Addendum No.: 1

Date Of Addendum: 09/07/18

Master Plan Phase III Renovations and Additions
Norwalk Community College
188 Richards Ave.
Norwalk, CT
BI – CTC – 467

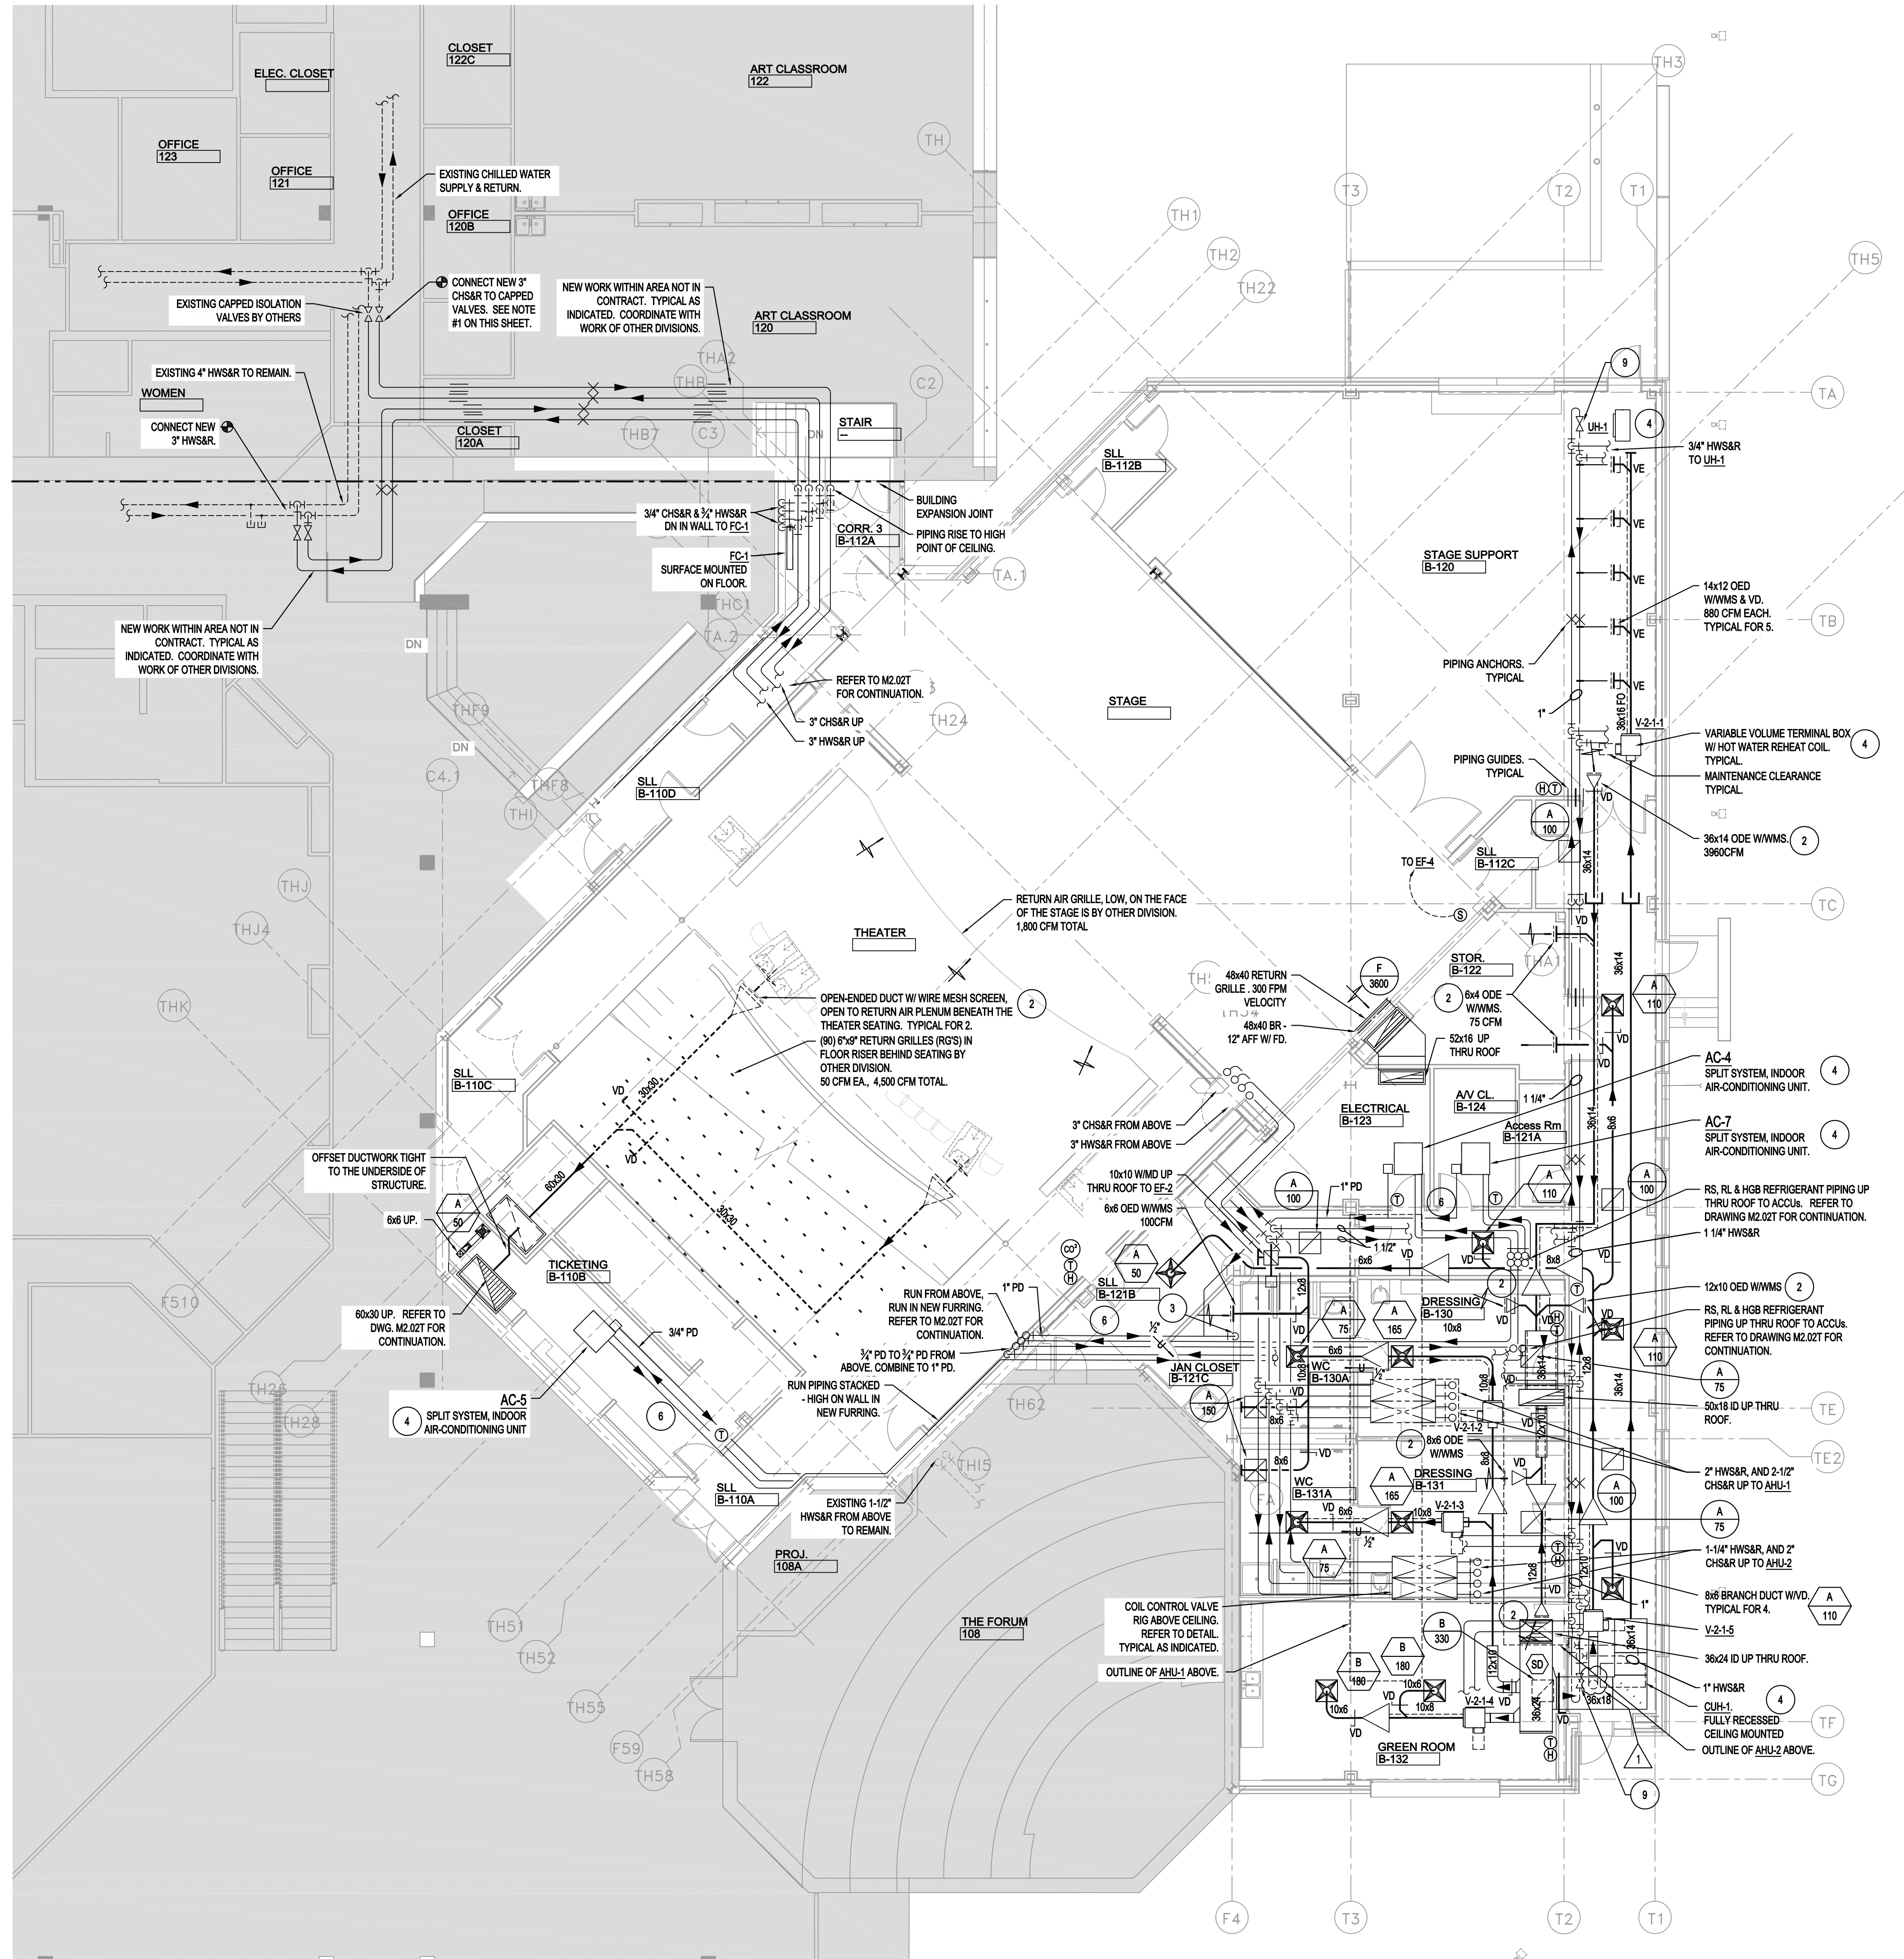
M2.10T – re-issued, Addendum No. 1, 09/07/18: Revised duct layout near grid TF & T1 to allow for required maintenance access clearance at the VAV.
